Addendum 47 – UN Regulation No. 48

Revision 12 - Amendment 10

07 series of amendments – Date of entry into force: 25 September 2020

Uniform provisions concerning the approval of vehicles with regard to the installation of lighting and light-signalling devices

"Arrangements of approval marks

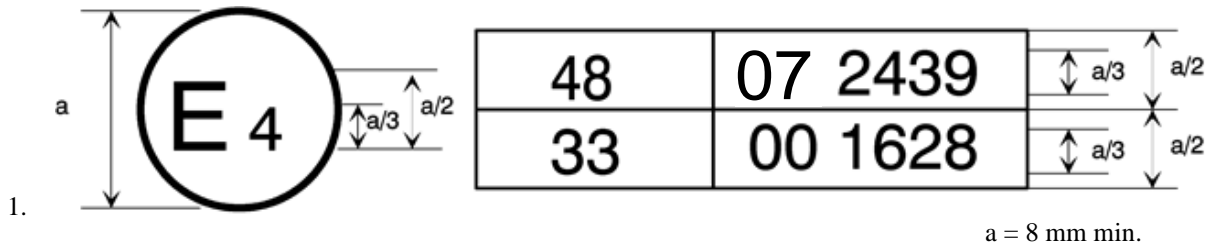
Annex 2, amend to read:

Model A
 (See paragraph 4.4. of this Regulation)

a = 8 mm min.

The above approval mark affixed to a vehicle shows that the vehicle type concerned has, with regard to the installation of lighting and light-signalling devices, been approved in the Netherlands (E 4) pursuant to UN Regulation No. 48 as amended by the 07 series of amendments. The approval number indicates that the approval was granted in accordance with the requirements of UN Regulation No. 48 as amended by the 07 series of amendments.

Model B
(See paragraph 4.5. of this Regulation)

The above approval mark affixed to a vehicle shows that the vehicle type concerned has been approved in the Netherlands (E 4) pursuant to UN Regulation No. 48 as amended by the 07 series of amendments and UN Regulation No. 33.⁵ The approval number indicates that, at the dates when the respective approvals were given, UN Regulation No. 48 was amended by the 07 series of amendments and UN Regulation No. 33 was still in its original form.
